Harnett County Department of Public Health Improvement Permit

RE: Flow Reduction Certification and As-built
Mason Pointe Lot 39
171 Piney Field Rd, Fuquay-Varina, Harnett County, North Carolina
Project #:2031

Mason Pointe Lot 39 AS BUILT

Harnett County Department of Public Health Site Sketch

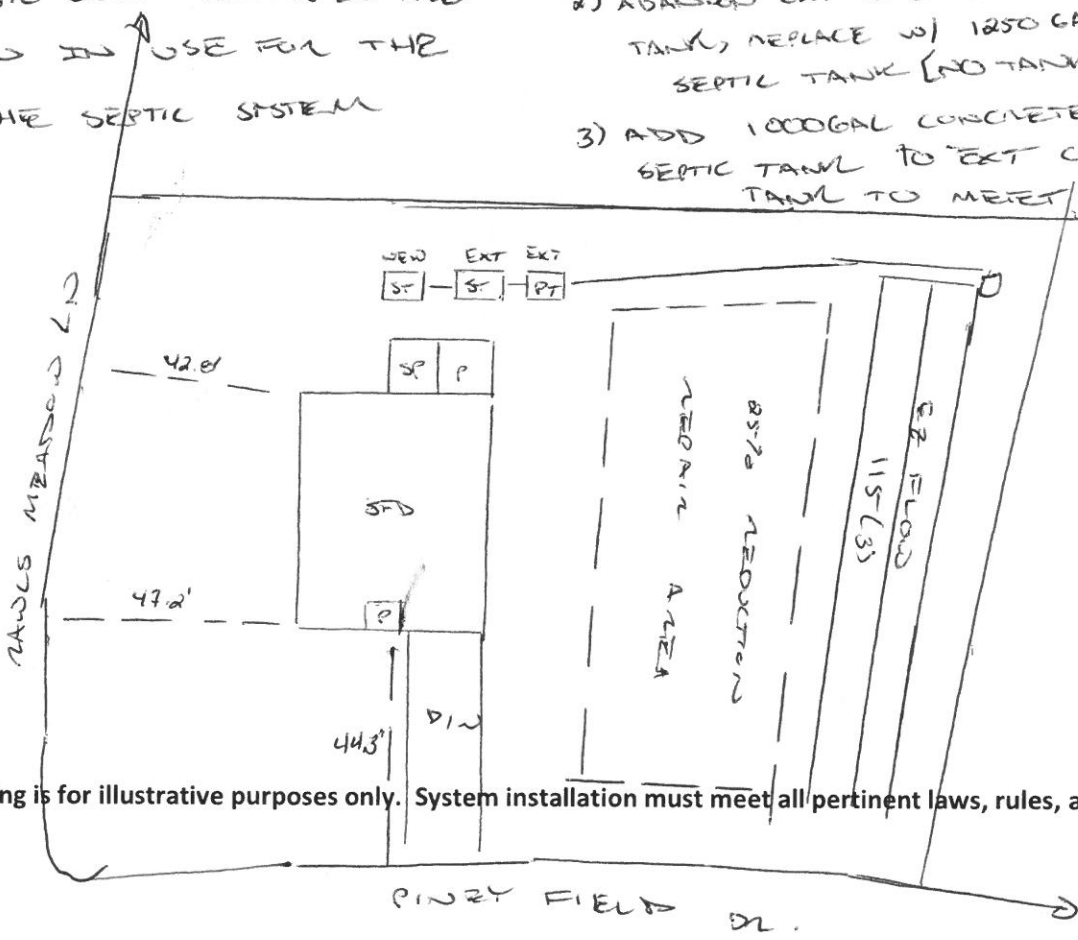
* SEPTIC PROPOSAL BY CENTRAL CAROLINA
SOIL CONSULTING, PLLC FOR
KB HOME RALEIGH-DURHAM
* CUTSHEETS OF SEPTIC TANKS AND
PUMP TANKS REQUIRED FROM
MANUFACTURER

- 1) ABANDON EXT 1000GAL CONCRETE SEPTIC TANK, REPLACE W/ 1250GAL CONCRETE SEPTIC TANK [TANK TRUCK REQUIRED]
- 2) ABANDON EXT 1000GAL CONCRETE SEPTIC TANK, REPLACE W/ 1250GAL PLASTIC SEPTIC TANK [NO TANK TRUCK REQ.]
- 3) ADD 1000GAL CONCRETE OR PLASTIC SEPTIC TANK TO EXT CONCRETE TANK TO MEET 1250GAL + CAPACITY
